Valley County Planning and Zoning

STAFF REPORT:	CUP 26-018 Nokes Elo RD Solar Panels
MEETING DATE:	August 13, 2026
TO:	Planning and Zoning Commission
STAFF:	Cynda Herrick, AICP, CFM Planning and Zoning Director
APPLICANT / PROPERTY OWNER:	Donna Nokes and Nokes Family Limited Partnership 1270 Elo Rd, McCall ID 83638
REPRESENTATIVE:	Claire Cameron, RevoluSun Mountain States 457 Steelhead Way, Boise ID 83704
LOCATION:	1270 Elo Road Parcel RP18N03E234956 in the NESW Section 23, T.18N, R.3E, Boise Meridian, Valley County, Idaho
REQUEST:	Ground-Mounted Solar Panel Array
EXISTING LAND USE:	Agricultural (Irrigated Pasture) with Home on 4.78 acres

SITE PLAN

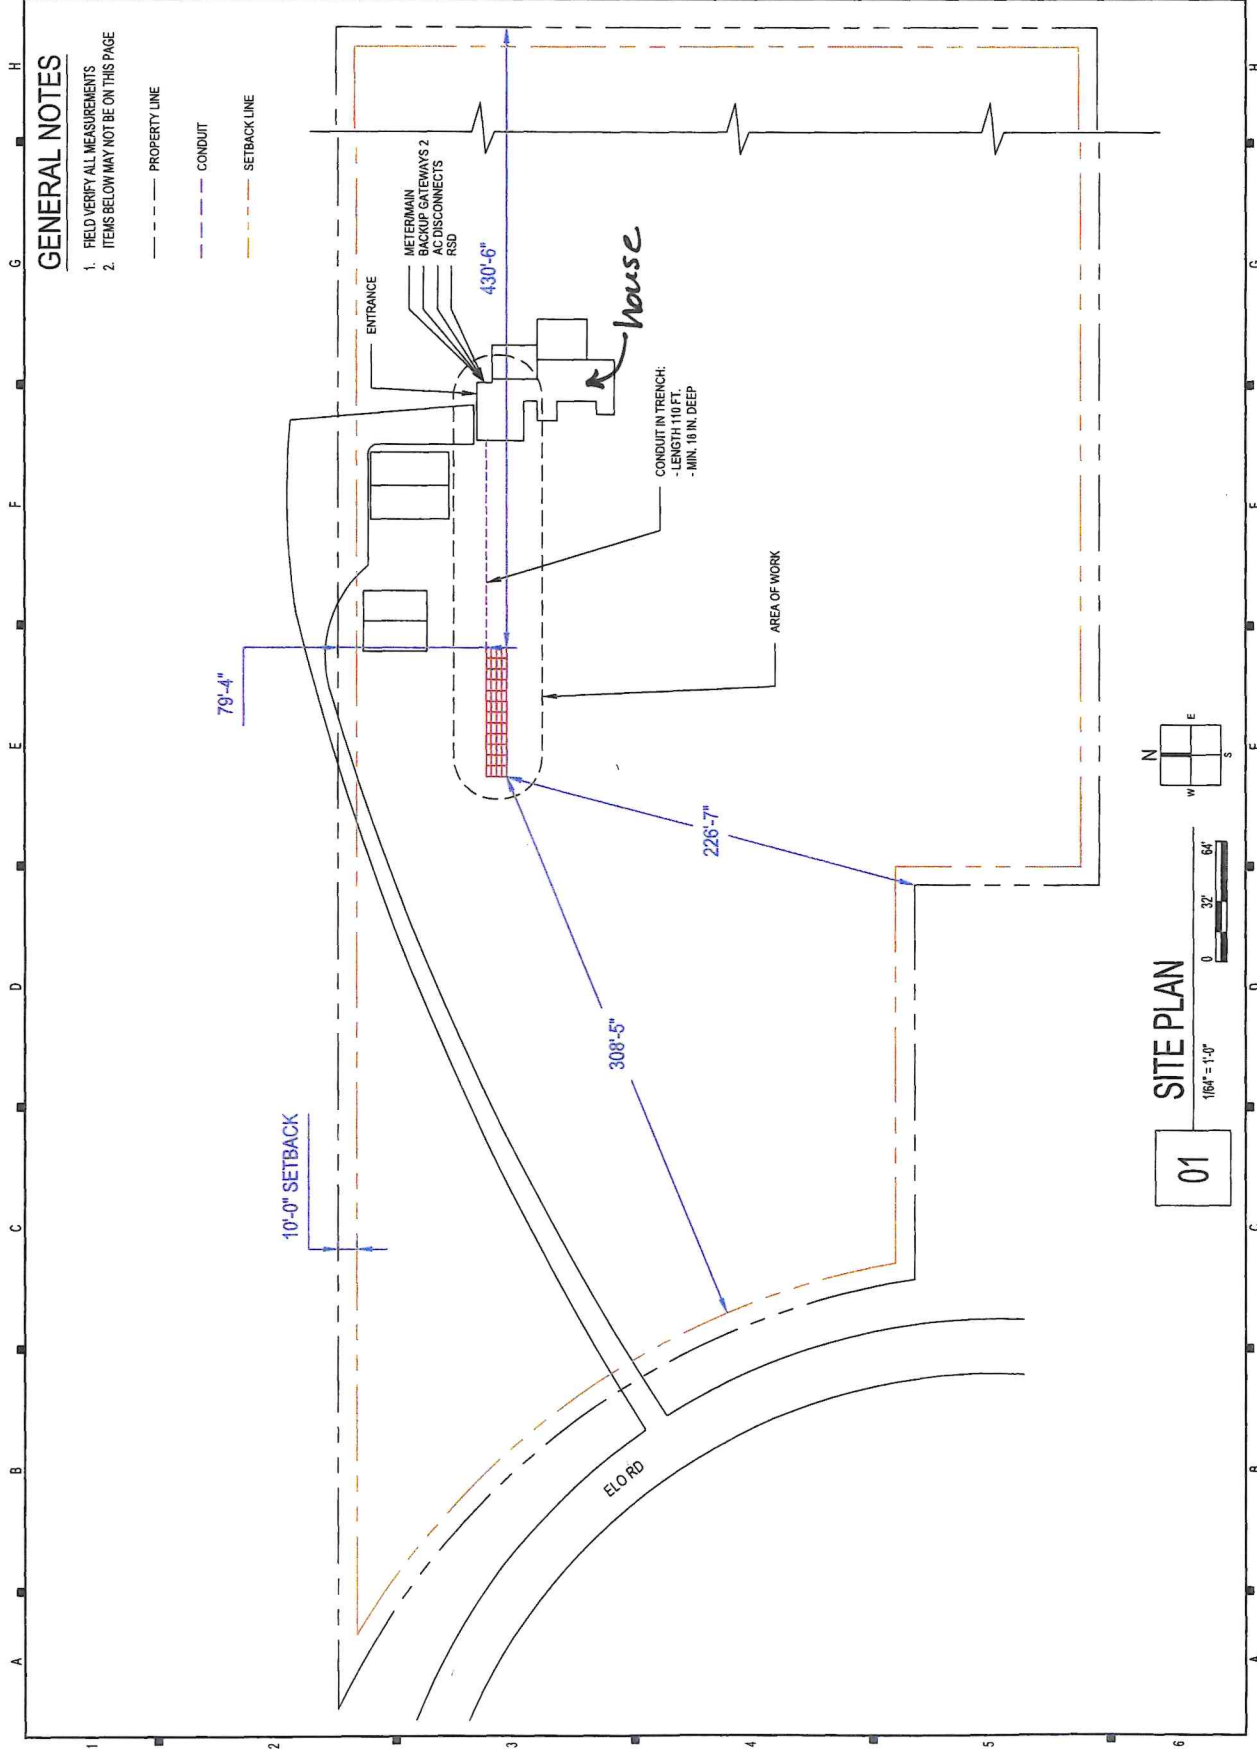
Emily Hart, McCall Airport Manager, stated the site is 2.14 miles from end of Runway 34 in Conical Surface. File FAA Form 7460-1 if required by prescreening. Airport will recommend denial if FAA issues a Determination of Hazard to Air Navigation. (July 20, 2026)

Ryan Garber, McCall Fire and EMS, stated the residence shall maintain a readily accessible utility service disconnect in accordance with applicable electrical code requirements. The photovoltaic system shall include the required PV system disconnecting means, and all disconnects shall be readily accessible and properly labeled in accordance with the National Electric Code requirements. (July 28, 2026)

C.U.P. 26-018 Nokes Elo Rd Solar Panels 2.14 miles from end of Runway 34. In Conical Surface. Select Solar Panel in <https://oeaaa.faa.gov/oeaaa/oe3a/main/#/noticePrescreen> and file FAA Form 7460-1 if required. Airport will recommend denial if FAA issues a Determination of Hazard to Air Navigation.

- The residence shall maintain a readily accessible utility service disconnect to allow the electrical service to the home to be disconnected in accordance with applicable electrical code requirements.
- The photovoltaic system shall include the required PV system disconnecting means, and all disconnects shall be readily accessible and properly labeled in accordance with the National Electrical Code (NEC) requirements.

4. Shall obtain an Accessory Use Application from Central District Health prior to submitting building permit.
5. Shall obtain building permit for the solar panel structures.

6. Shall meet requirements of McCall Fire Department.
7. All noxious weeds on the property must be controlled.
8. All exterior lighting on-site must be dark sky compliant.
